#22013P

Wired & Wireless
Network Infrastructure
Addendum #1

Friday January 21, 2022

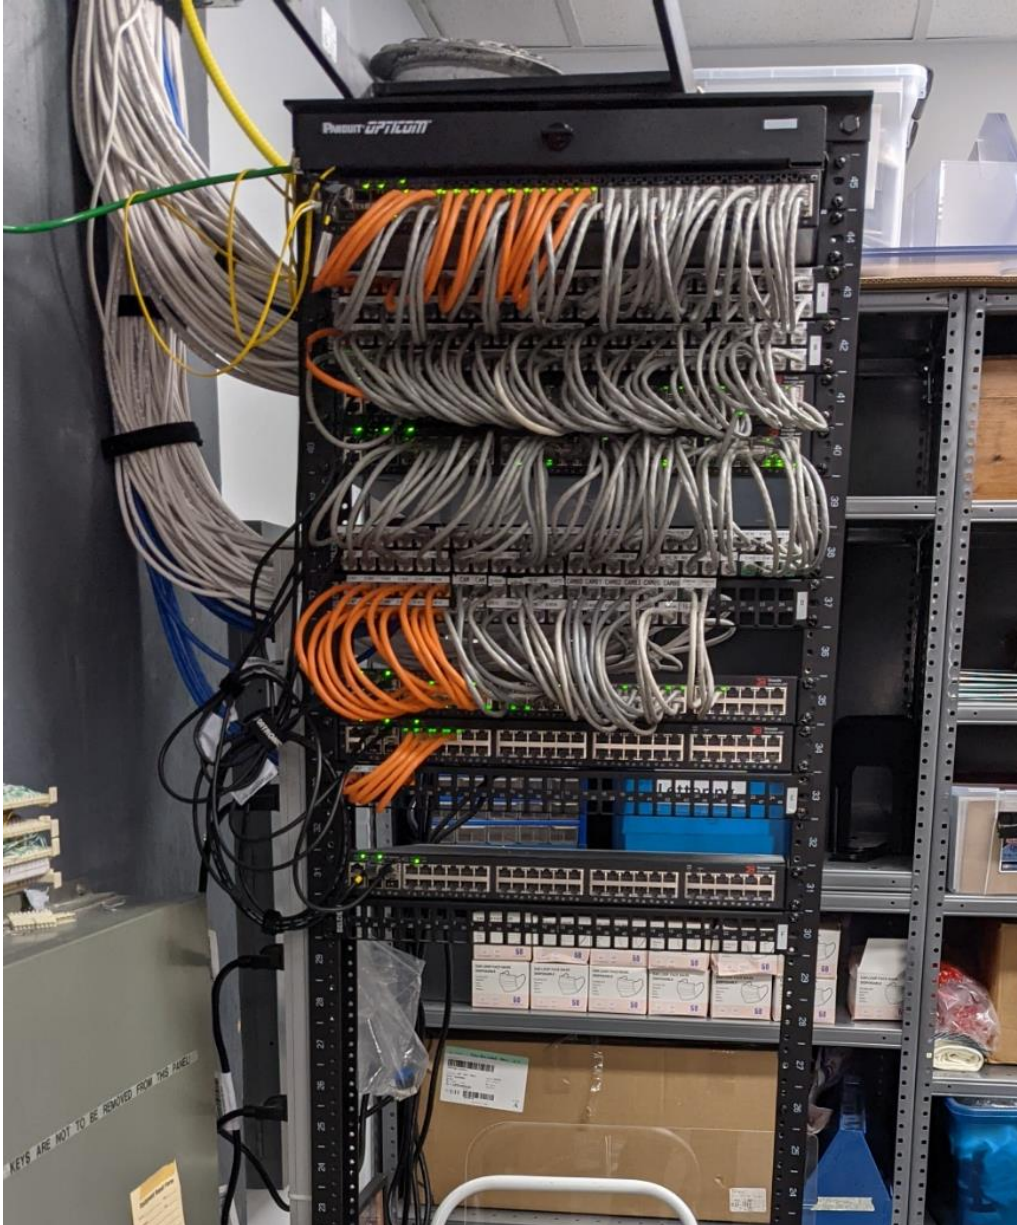
11. Do you have topological diagrams of the WAN and/or LAN diagram that you can share? **Yes, see the attached diagram. The document may not be as accurate as the list of devices in the RFP. Use the RFP for actual switch counts.**
